This drawing is issued for customer approval. please review, make approval changes (if any) in red. check the appropriate box, sign & date.

SYLVAMO
SEAL TANK STAND PIPE
EQUIP. #472-5-3584-00B
CUST. PO #S0769C8106

DRAWING NO.: 357-25-1 SHT 1 OF 3 REV. SET 2

NOZZLE E DETAIL

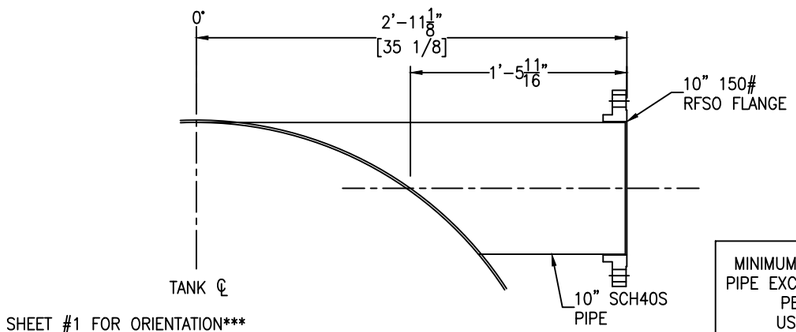
MINIMUM THICKNESS REQUIRED FOR THE PIPE EXCEEDS SCH10 PIPE THICKNESS AS PER API 650 CALCULATIONS. USING SCH40S PIPE INSTEAD. PLEASE CONFIRM

NOZZLE C DETAIL

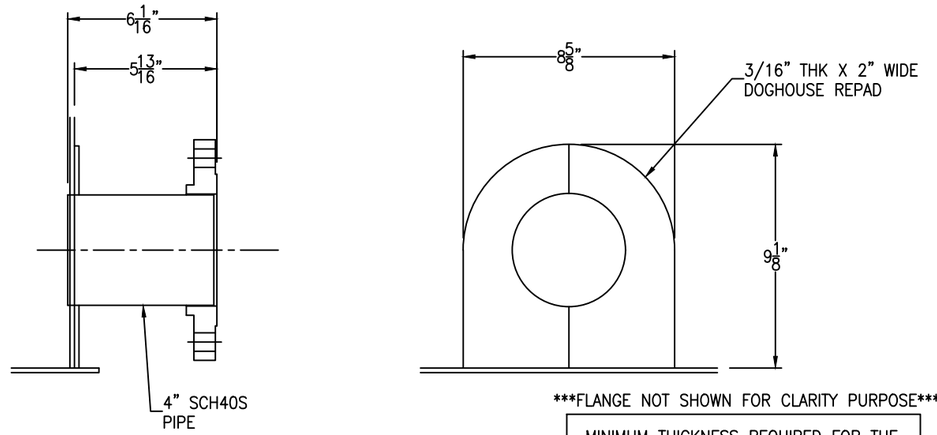
MINIMUM THICKNESS REQUIRED FOR THE PIPE EXCEEDS SCH10 PIPE THICKNESS AS PER API 650 CALCULATIONS. USING SCH40S PIPE INSTEAD. PLEASE CONFIRM
